**Re: Gordon Property – 257 East Middle Patent Road  
Tax ID: 88.04-1-13, R-4A Zone, 114.5 Acres  
Proposed Driveway Curb Cut Modifications  
Revised & New Information**

*The following information is provided in response to the Town Planner's (TP) Staff Report Memo, dated May 24, 2021, General Comments on page 2 of 2.*

*The following information responds to comments noted in the TE's Review Memorandum for the project, dated May 20, 2021. The following responses to the "General Comments" 1-15 are provided below.*

## GORDON PROPERTY PROPOSED DRIVEWAY REALIGNMENT

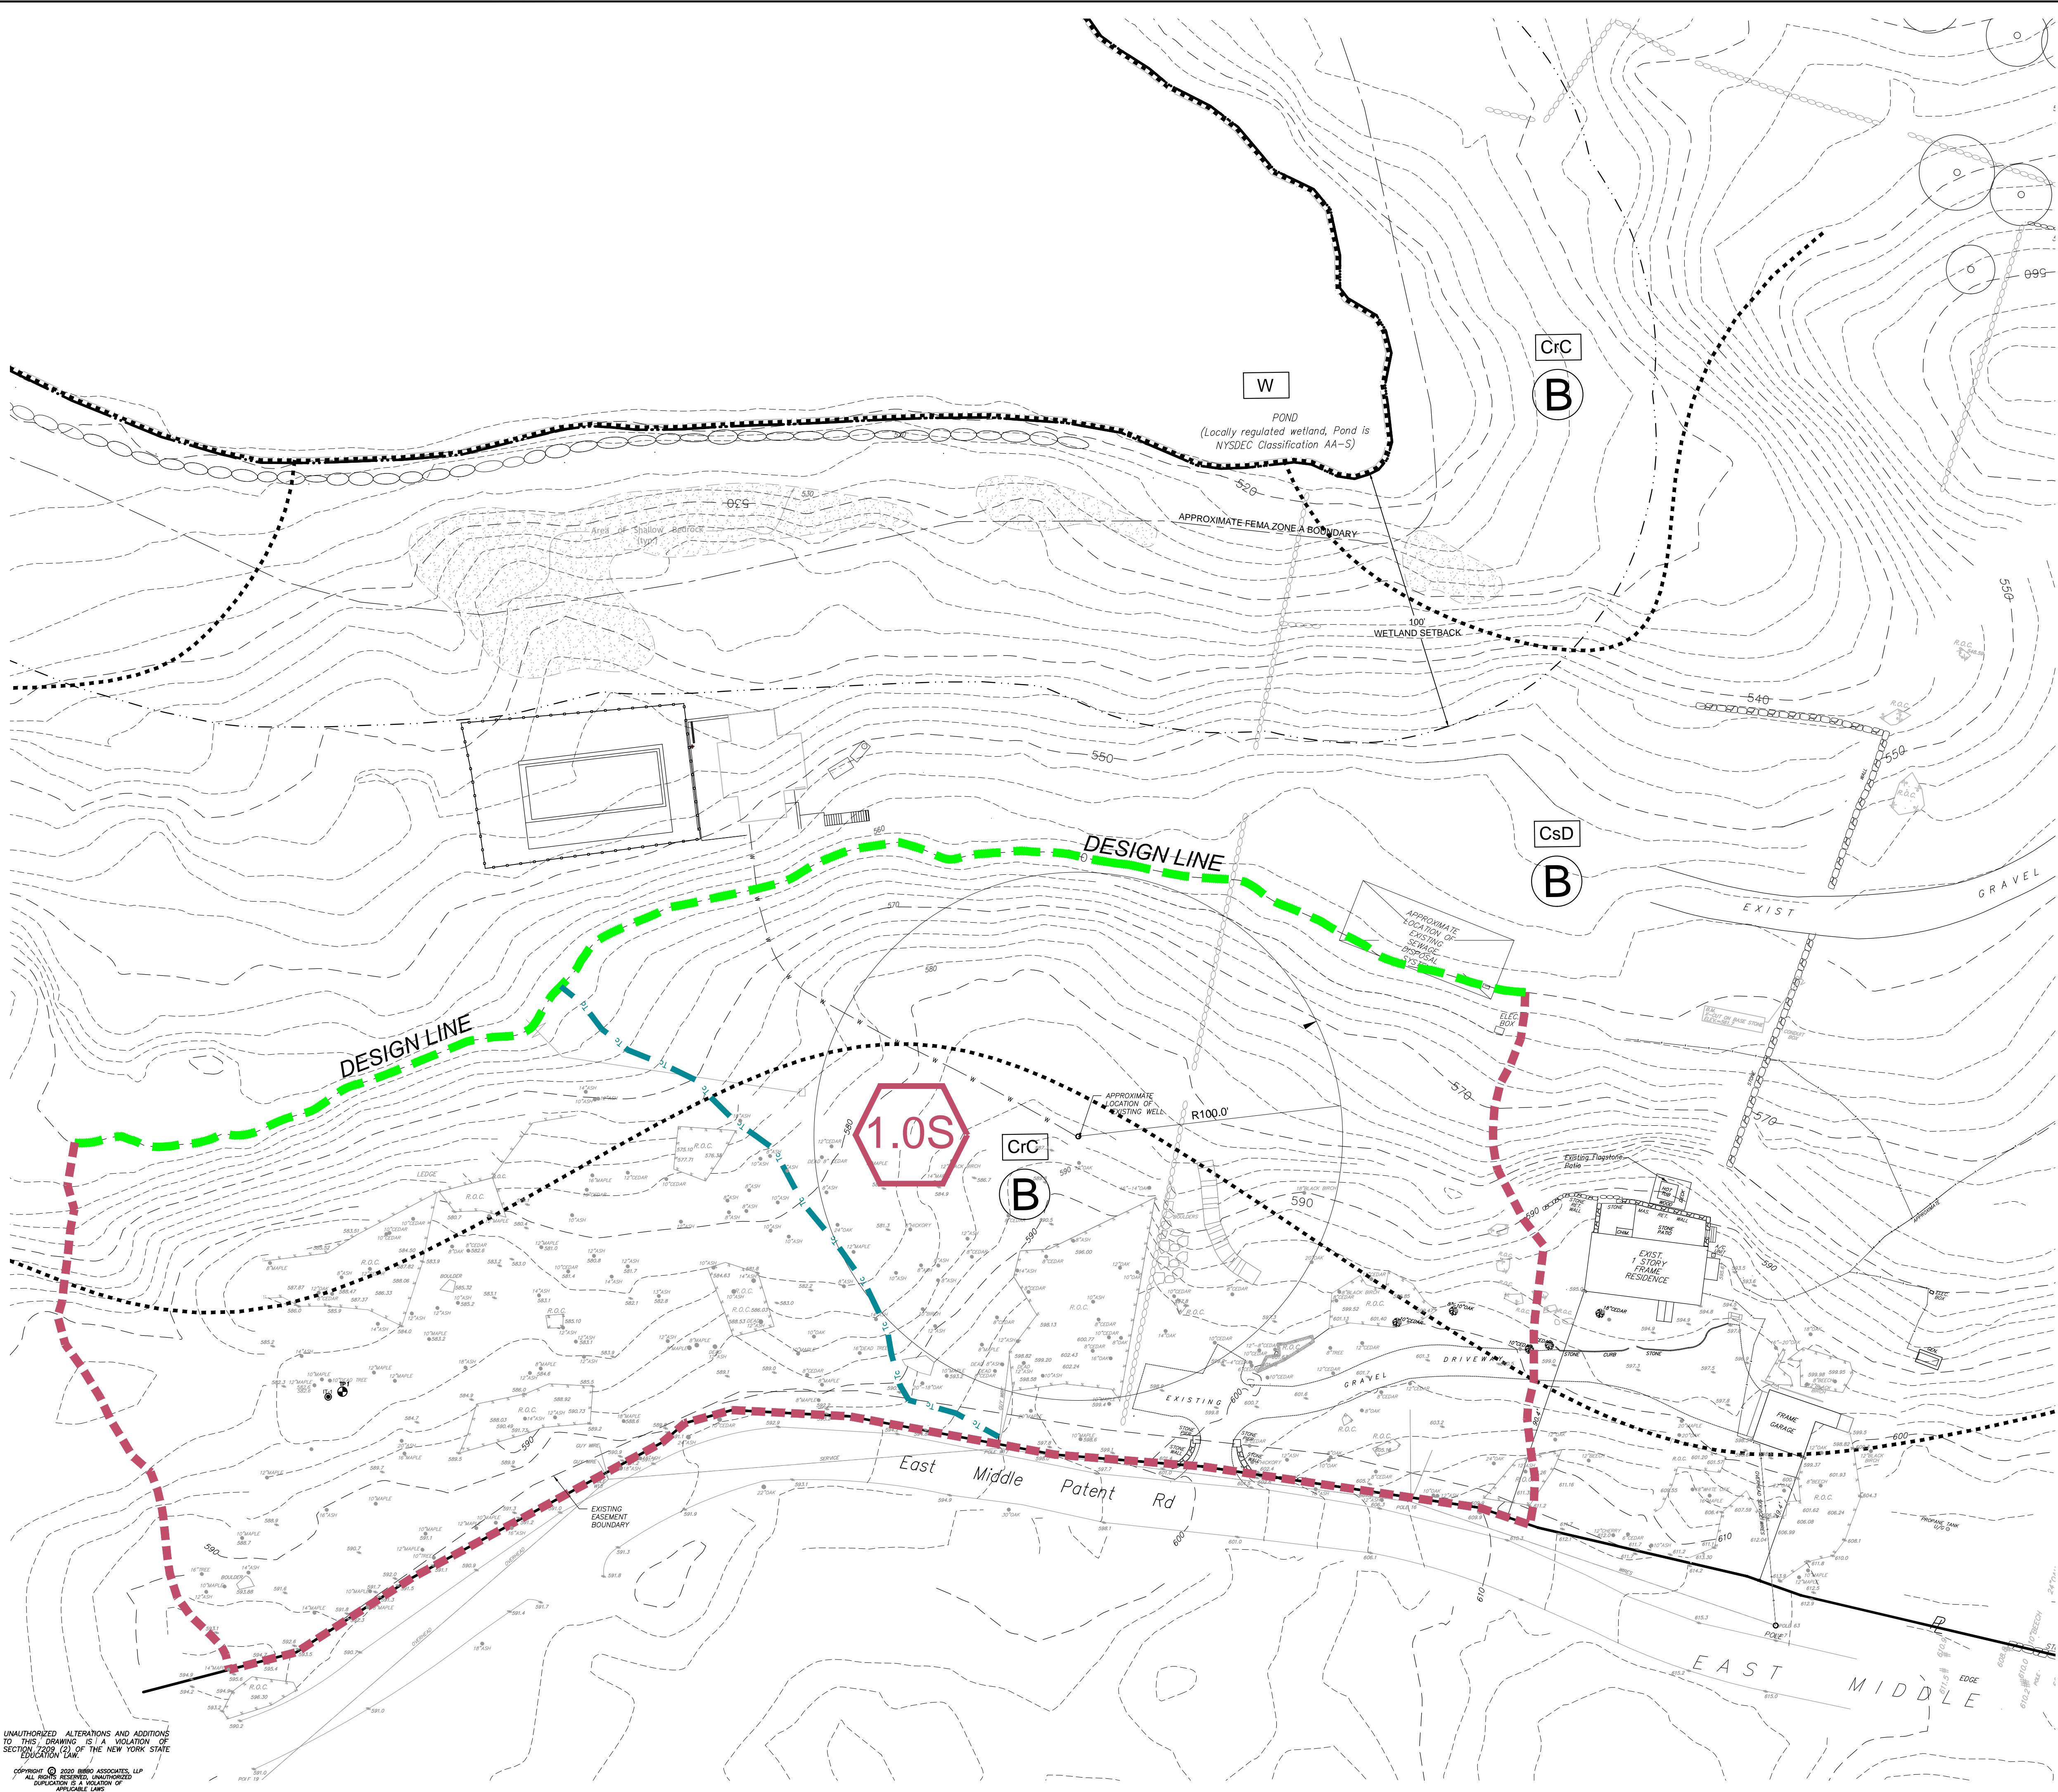
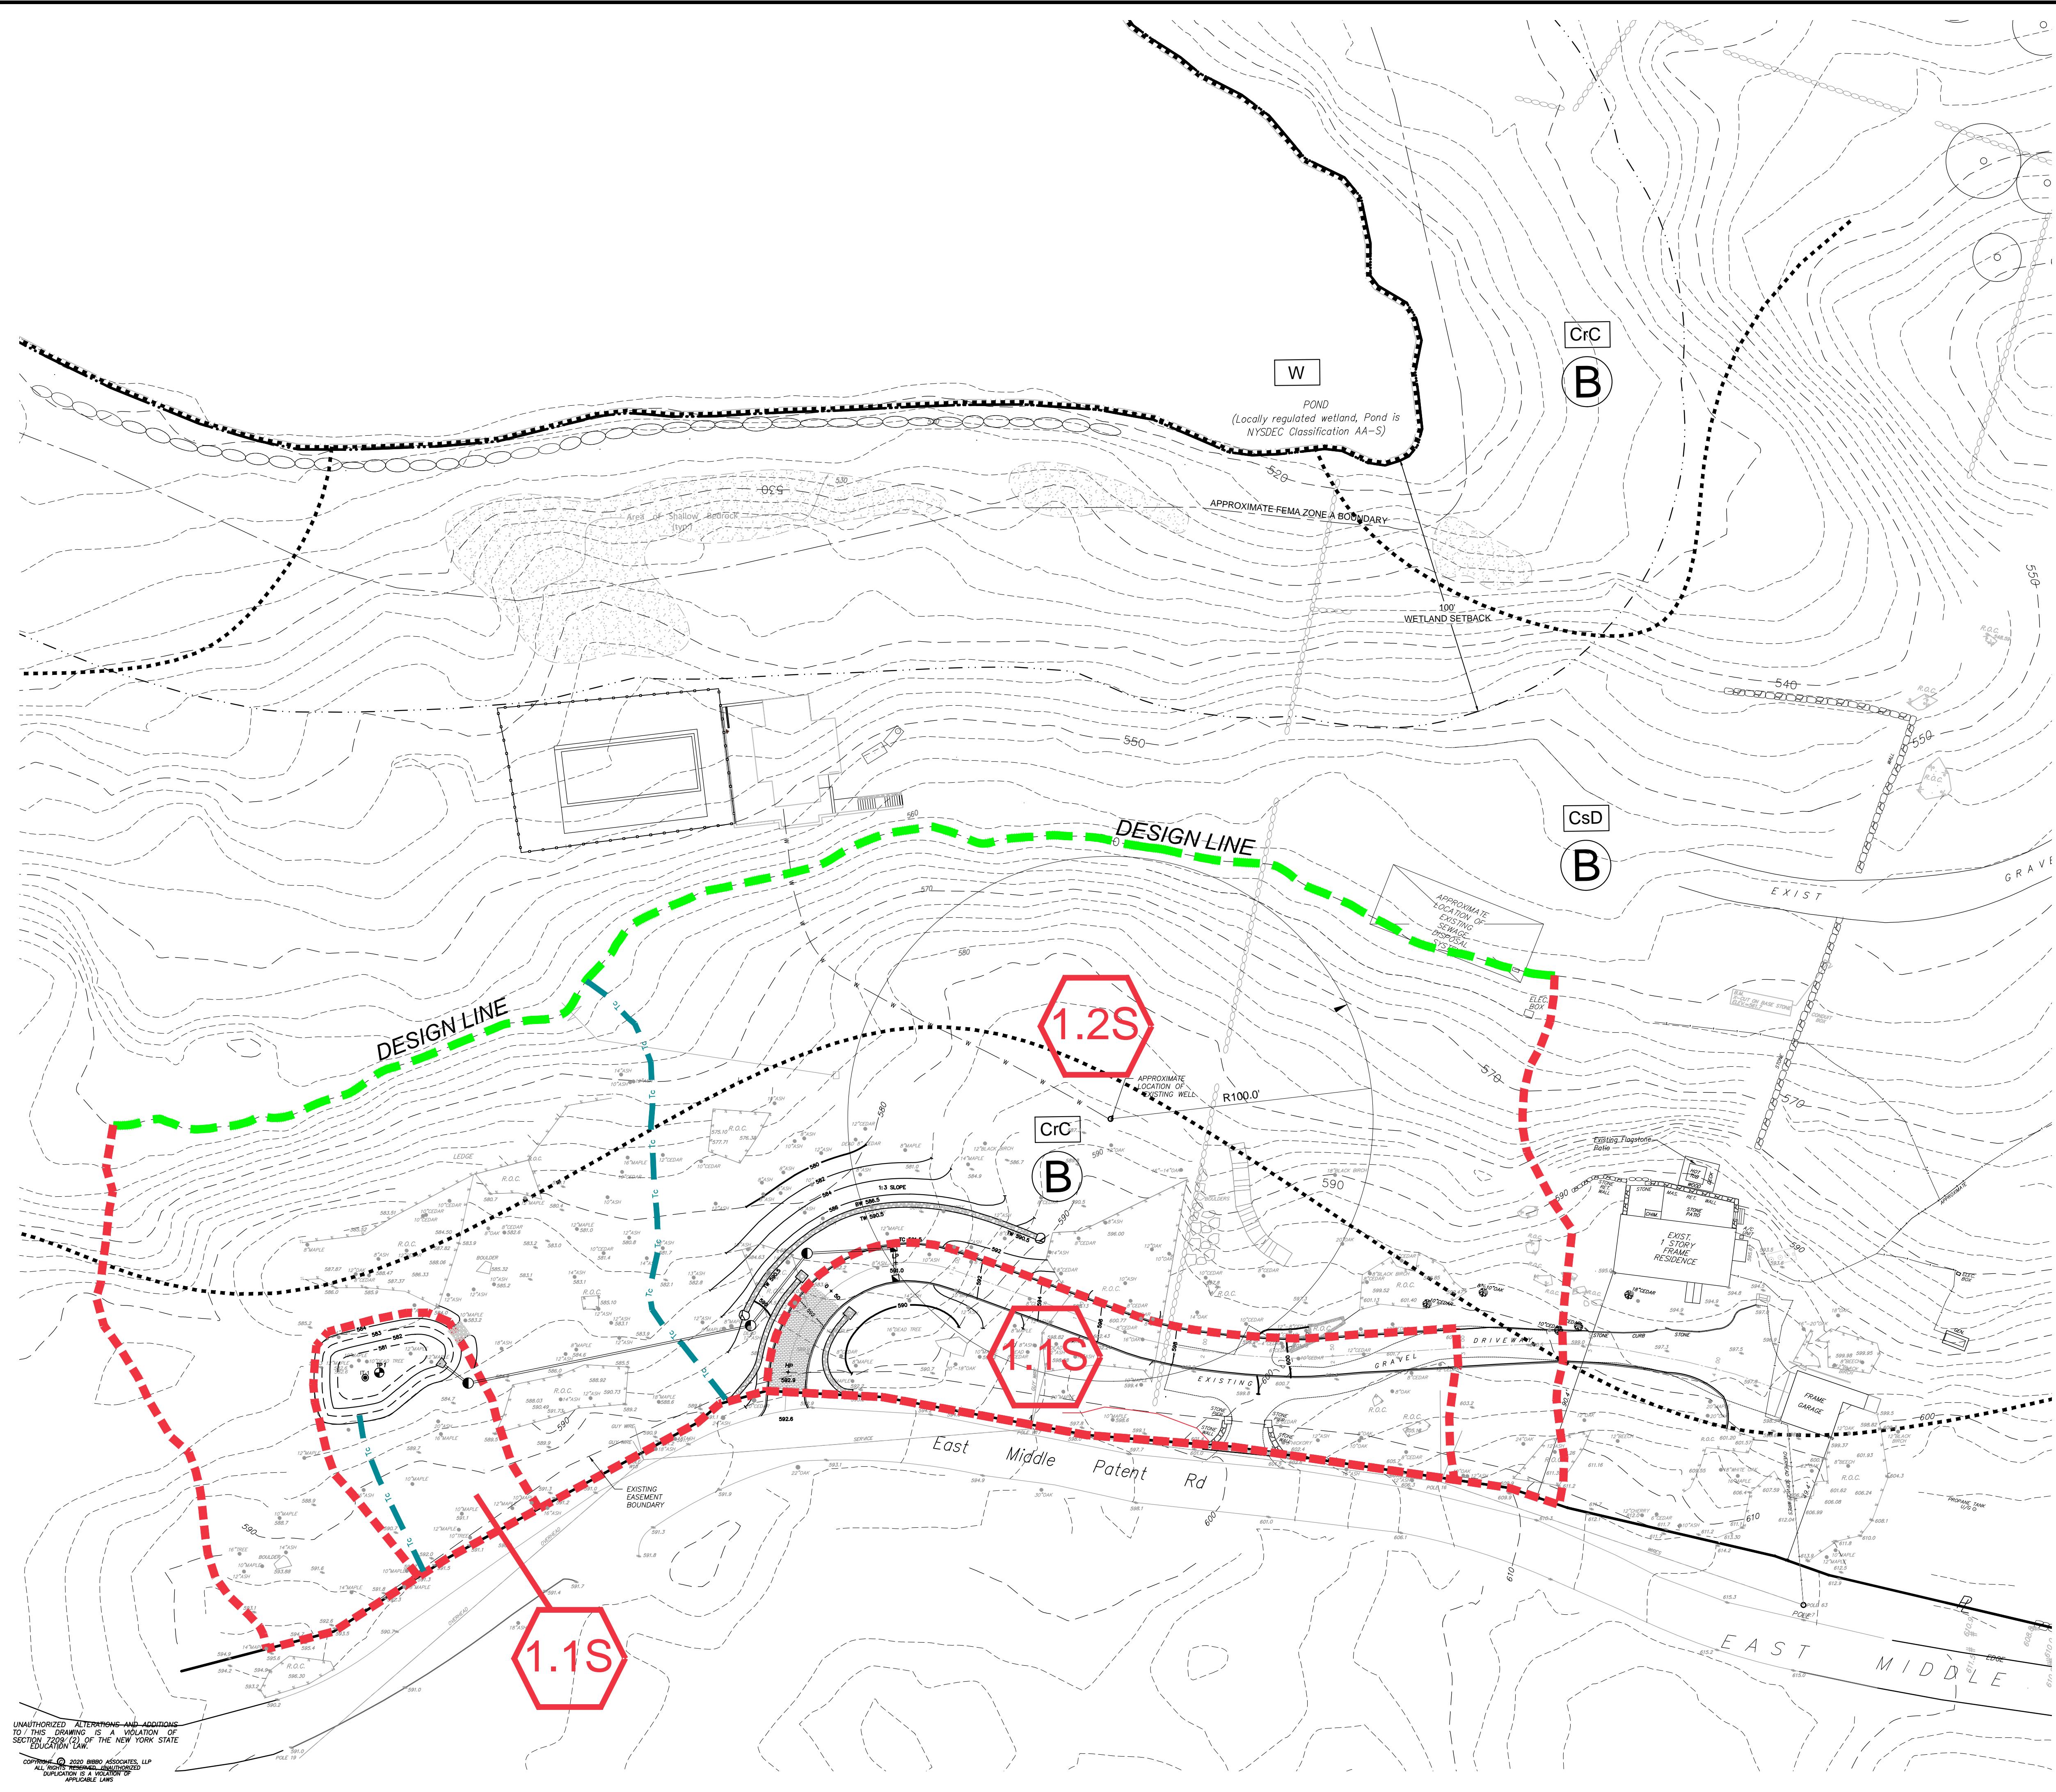
4. A completed Floodplain development permit application is enclosed as requested.
8. In accordance with town requirements a Stormwater Pollution Prevention Plan (SWPPP) has been prepared for the project and is included herewith. Stormwater runoff generated by the proposed impervious/gravel surfaces will be captured and treated in an Infiltration Basin designed for the purposes of provided peak flow attenuation for the 25-year storm event. The enclosed SWPPP includes a peak flow analysis which indicates 25-year storm peak runoff rates will be less than predevelopment conditions.
